United States Patent and Trademark Office

APPLICATION NO.	F	ILING DATE	FIRST NAMED INVENTOR	ATTORNEY DOCKET NO.	CONFIRMATION NO.
10/791,514	10/791,514 03/01/2004		Henri V. Azibert	CTH-302 2753	
959	7590	06/21/2006		EXAMINER	
LAHIVE & COCKFIELD 28 STATE STREET				LEE, GILBERT Y	
BOSTON, MA 02109				ART UNIT	PAPER NUMBER

DETAILED ACTION

FIG. 2

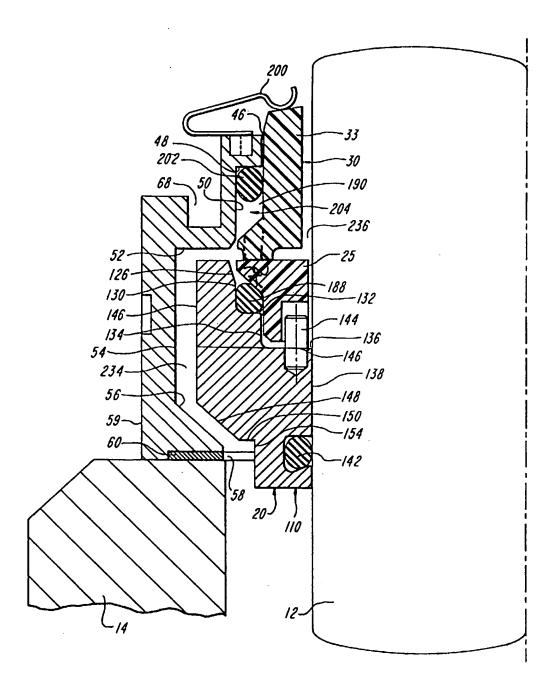
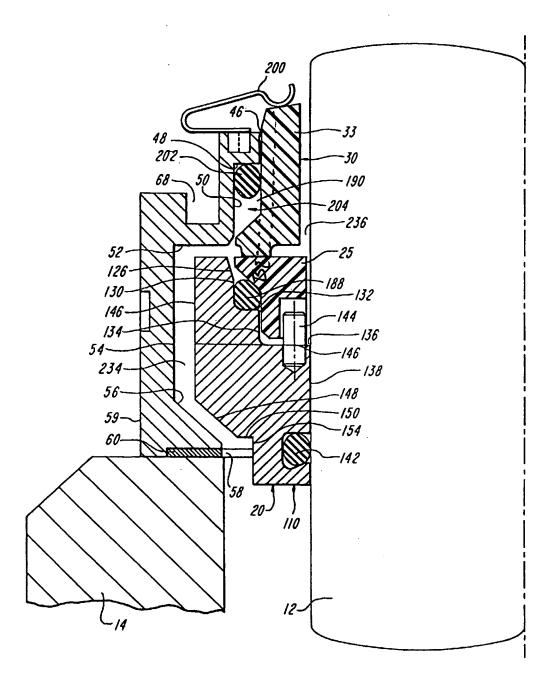
Note for reference characters A and B refer to the Examiner's Attachments A & B.

Regarding claim 18, the Clark et al. reference discloses a first piston area (A) defined by an outer edge of the radially extending seal face of one of the seal rings and an axially extending, inner surface of the shuttle member (Fig. 2), and

a second piston area (B) defined by an inner edge of the radially extending seal face of one of the seal rings and an axially extending, inner surface of the shuttle member (Fig. 2).

Regarding claim 19, the Clark et al. reference discloses the first piston area and the second piston area being **about** equal in size (See Examiner's Attachments A & B).

Regarding claim 20, the Clark et al. reference discloses the first piston area and the second piston area being smaller than a contact area of the rotary seal face and the stationary seal face (See Examiner's Attachments A & B).

Regarding claim 37, the Clark et al. reference discloses defining a first radially extending piston area (B) on the rotary seal ring for biasing the rotary seal ring against the stationary seal ring under the first pressure condition (Fig. 2), and

defining a second piston area (A) on the rotary seal ring for biasing the rotary seal ring against the stationary seal ring under the second pressure (Fig. 2).

Regarding claim 38, the Clark et al. reference discloses defining a first piston area (B) defined by an outer edge of the radially extending seal face of one of the seal rings and an axially extending, inner surface of the shuttle member (Fig. 2), and

defining a second piston area (A) defined by an inner edge of the radially extending seal face of one of the seal rings and an axially extending, inner surface of the shuttle member (Fig. 2).
